# UNITED STATES PATENT AND TRADEMARK OFFICE

APPLICATION NO.	FILING DATE	FIRST NAMED INVENTOR	ATTORNEY DOCKET NO.	CONFIRMATION NO.
10/582,046	10/31/2006	Gustav Strobel	06-387	9279
34704 7590 07/29/2010 BACHMAN & LAPOINTE, P.C. 900 CHAPEL STREET SUITE 1201 NEW HAVEN, CT 06510				
EXAMINER				
RODDEN, JOSHUA E				
ART UNIT		PAPER NUMBER		
3637				
MAIL DATE		DELIVERY MODE		
07/20/2010		PAPER

### Office Action Summary

### **DETAILED ACTION**

Annotated Figure 4. (Strobel)

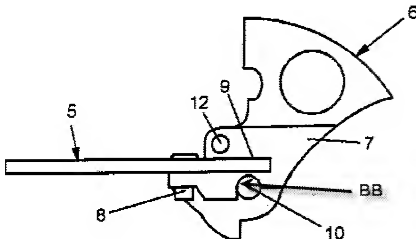
However, **Strobel** teaches: **Claim 12** - a stacking column comprising two side walls (2 and 3), and a plurality of latches (4.1 and 4.2) arranged between the side walls (2 and 3), wherein each latch (4.1 and 4.2) is on a pin (11.1 and 11.2) which allows for rotation of the latches (4.1 and 4.2) between a rest position and a working position (See the “BACKGROUND OF THE INVENTION” section of the specification), (Figures 1-3); wherein the bottom portion of the latch has hole (10) for engaging the pin (11.1 and 11.2) and additionally has an arcuate surface (BB) which only partially surrounds the circumferential surface of the pin (11.1 and 11.2), (Figures 1-4 and Annotated Figure 4 Below); wherein at least two pins (11.1 and 11.2) maintain a distance from each other which is greater than and substantially the same as a material thickness of the latch (4.1

or 4.2) in the region of the pin holder (10 and BB) such that it is not possible for the pin to slip out of the pin holder while the pivotability of the latch about the pin is ensured, wherein it should be understood that the latches could not be removed as the latches (4.1 and 4.2) have the hole (10) which engages the pin (11.1 and 11.2), (Figure 1 and Annotated Figure 4 below).

Therefore, it would have been obvious to one of ordinary skill in the art to modify the latches and pins of **Weidner** to have wherein at least two pins maintain a distance from each other which is greater than and substantially the same as a material thickness of the latch in the region of the pin holder such that it is not possible for the pin to slip out of the pin holder while the pivotability of the latch about the pin is ensured (**Claim 12**) as taught by **Strobel** for the purposes of having latches which can be located closer to one another for holding smaller objects.

Annotated Figure 3 (Weidner)

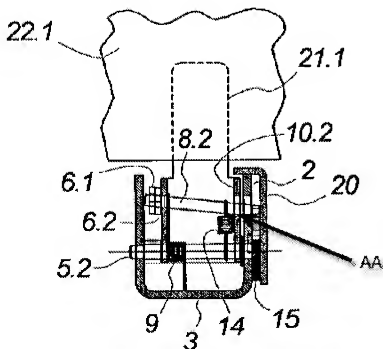
Regarding **Claims 13, 20 and 21**, **Weidner as modified by Strobel** teaches the stacking column as described above, in addition to **Weidner** teaching: **Claim 13** -

wherein the latches (21.1-21.3) are assigned a locking device (6.1-6.3, 8.1-8.3, 12.1-12.3 and 13.1-13.3) which fixes at least some of the latches (21.1-21.3) in the working position, (Figures 1-4); **Claim 20** – wherein a stop lug (8.2) projects from the upper part of the latch (21.1) to stop the latch (21.1) from rotating to far in a given direction, (Figure 3); **Claim 21** – wherein the locking device (8.1-8.3) moves (up and down) in the cutout (upper and lower portions of hole (AA)) by means of a small rail (8.2), (Figures 1-4 and Annotated Figure 3 Below).
